September 27, 2022

CHAIR AND CULTURAL HERITAGE COMMISSIONERS  
City of Long Beach  
California

Approve a Certificate of Appropriateness to construct a new detached one-story 990-square-foot Accessory Dwelling Unit (ADU), and new detached single story-1,085-square-foot secondary unit with an attached 400-square-foot two-car garage, subject to Conditions. The property is located at 2518 Olive Avenue within the R-2-N Zoning District and is a Contributor to the Sunrise Boulevard Historic District. (District 6).

APPLICANT: Gabriel Alvarez  
8311 Rosecrans Ave  
Paramount, CA 90723  
(Application No. COAC2205-01)

Figure 1A

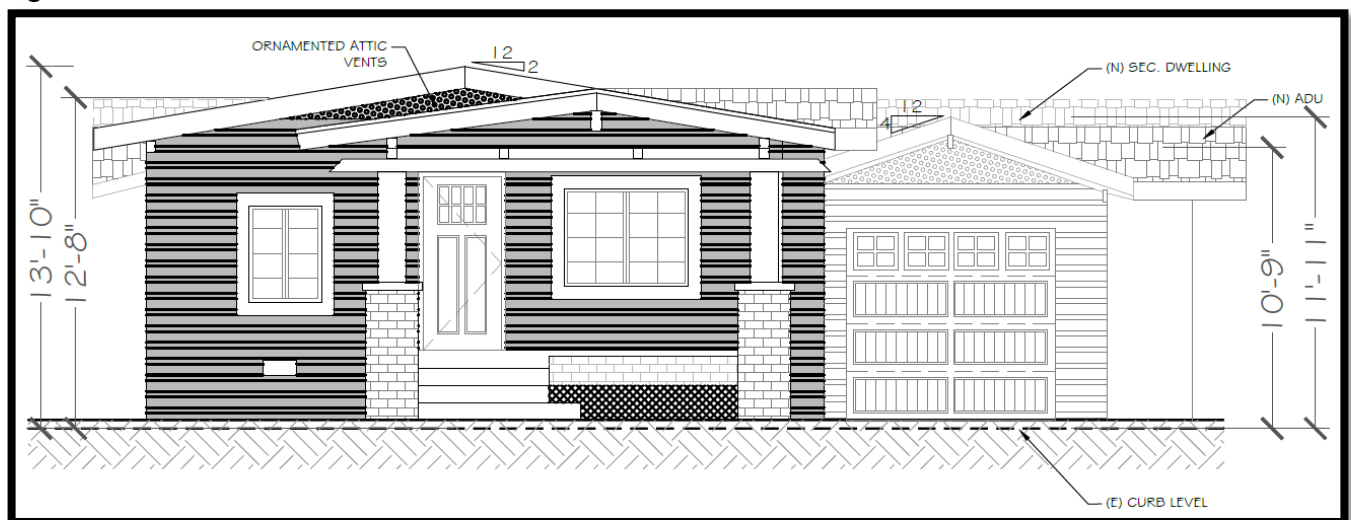
The proposed project requires approval of the Cultural Heritage Commission (CHC) due to the visibility of the proposed project from the street (See Figure 1A) and because the proposed construction exceeds 250 square feet. In order for approval to be granted, the project must comply with the *Secretary of the Interior's Standards (for Rehabilitation, New Construction)*, and meet the Criteria for the issuance of a Certificate of Appropriateness. No changes are proposed to the existing primary dwelling as part of this application.
